SI M17 09 12
Cooling Systems

This Service Information bulletin supersedes SI M17 09 12 **dated November 2012.**

Service Action: Retrofit of the Engine Coolant Temperature Sensor

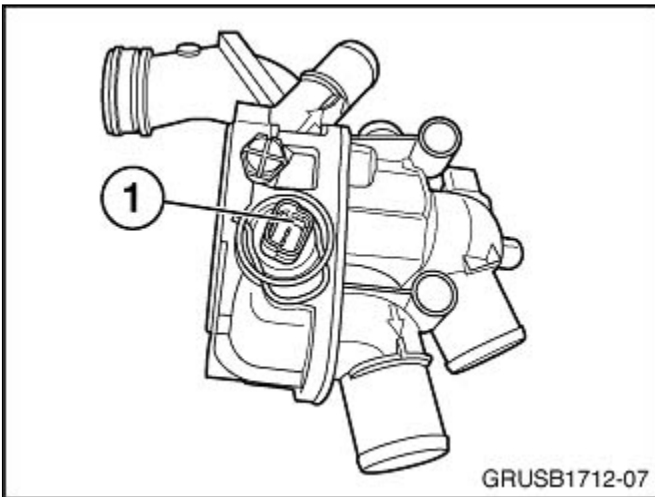
NEW There are two approved repair procedures, depending on parts availability. Both procedures involve installing an engine temperature sensor remotely and wiring this new sensor into the vehicle's engine harness. Only perform one of these recommended procedures when completing this Service Action.

NEW **Procedure One** requires the replacement of the upper coolant hose with a modified hose that houses a new engine temperature sensor. An adapter harness needs to be fitted to the car to utilize this new sensor.

NEW Procedure Two requires the installation of a new engine temperature sensor, with integrated wire harness, installed in place of the thermostat bleeder screw.

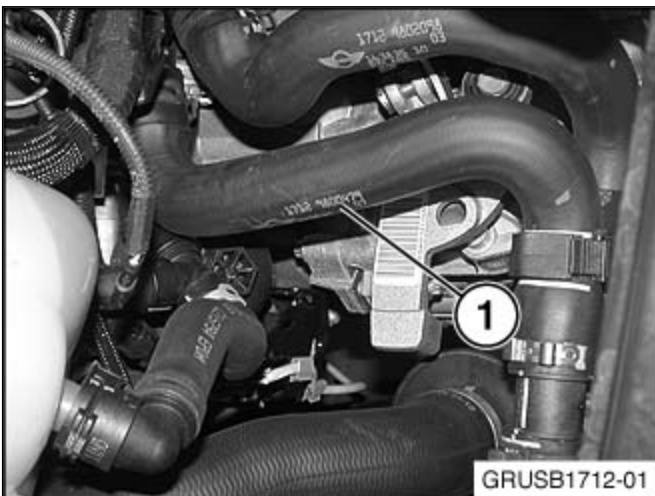
NEW Note: This Service Action does not apply to any N16 engine that had a thermostat replaced with P/N 11 53 7 534 521. Vehicles equipped with the N16 engine may have had repairs performed prior to this Service Action, so installing this remote sensor and hose or the sensor in place of the bleeder screw is no longer required.

NEW The 11 53 7 534 521 thermostat would need to be installed in conjunction with an engine electrical wiring harness replacement. This thermostat already has an updated, replaceable engine temperature sensor.

Checking for updated thermostat: The 11 53 7 534 521 thermostat has a replaceable engine temperature sensor (1).

- Replace the engine wiring harness with the 11 53 7 534 521 thermostat.
- Do not install the remote engine temperature sensor. Claim the labor operation “Check for 11 53 7 534 521 thermostat installation” in the Warranty Information section of this bulletin.
- Affix the Service Action label to the B-pillar.
